QUEENSLAND FLOODS
COMMISSION OF INQUIRY

STATEMENT OF RONALD (RON) KEITH GUPPY

Subject: Revised North Pine Dam Flood Mitigation Manual for your comments

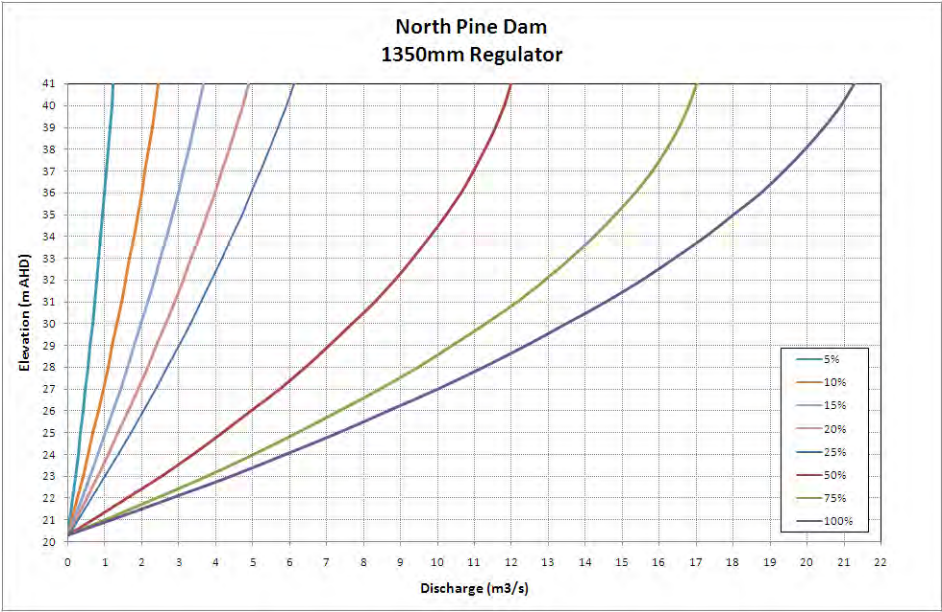
Comment [r20]: Is there a minimum opening that should be used?

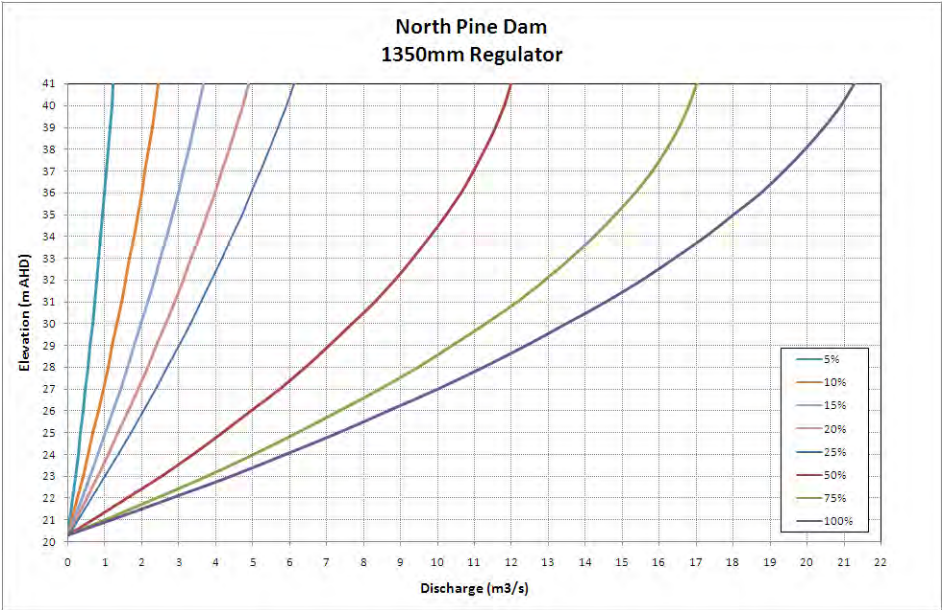
Comment [r3]: Is there a minimum opening that should be used?
